ANN ARBOR HISTORIC DISTRICT COMMISSION

Staff Report

ADDRESS: 614 Second Street, Application Number HDC19-158

APPLICATION: The applicant seeks HDC approval to remove a portion of the one-story wing on the back of the house and replace it with a new, wider one-story wing with an expanded roof deck.

PROPOSED FOUNDATION PLAN

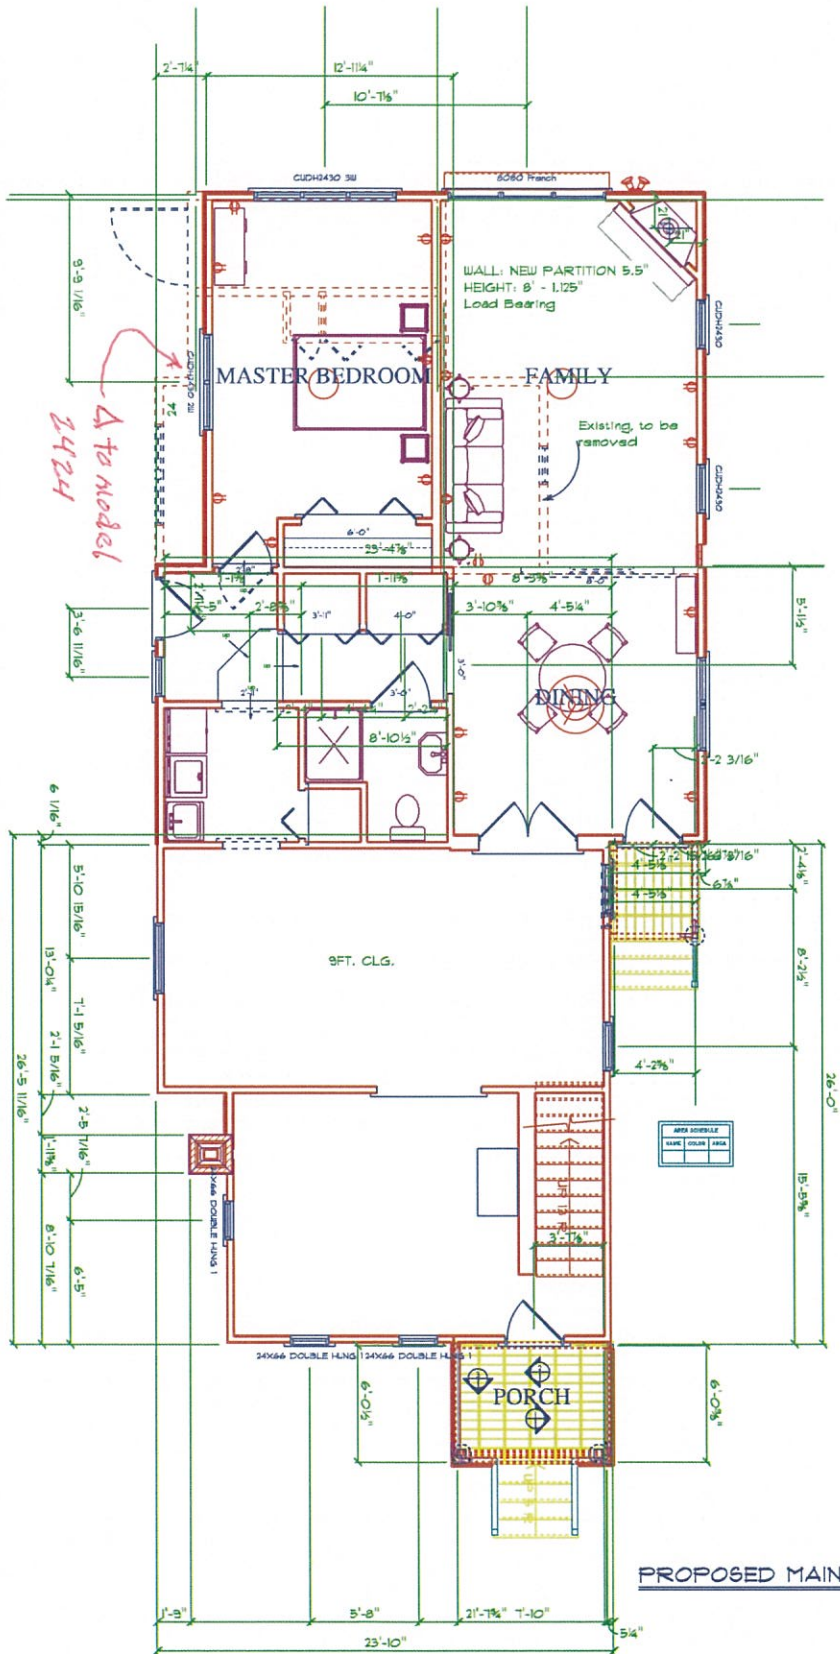
2. The new footprint of the additions (172 SF) would be 13% of the original footprint (1300 SF). This does not account for the demolished and replaced structure, which is part of the 1300 SF). The floor area of the additions (503 SF) adds 29% to the original (1708 SF). This meets the Ann Arbor design guideline that says "The addition should exceed neither half of the original building's footprint nor half of the original building's total floor area".

3. The new addition is a single-story rectangle off the back. Like the current design, it has a roofdeck for the second floor bedroom, though the new deck will be larger than the old. The addition creates a 2'7" corner on the south elevation where the existing additions will be removed. This is appropriate since it is the more visible, driveway side of the house.

RIGHT ELEVATION 4

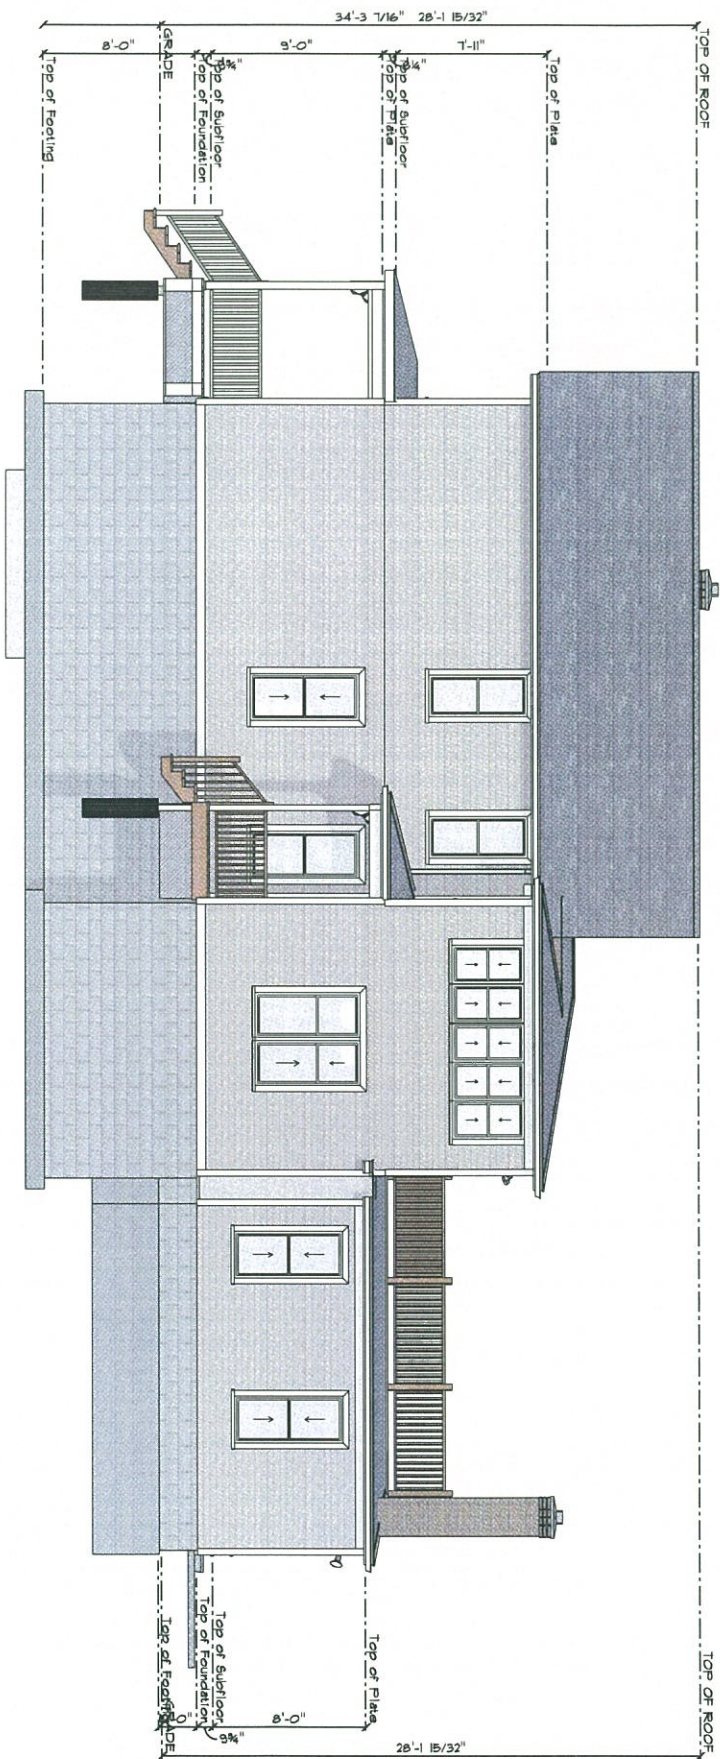
On the north elevation the inset is the depth of the 4" corner trim board, and 14 ½" wide. The cladding in this vertical band is different--fiber cement board instead of wood lap siding. Though a more pronounced break would be preferable to make the addition more subordinate, the second-story corner of the historic house is not impacted, and the change in foundation material (from stone to block) will also be very visible.
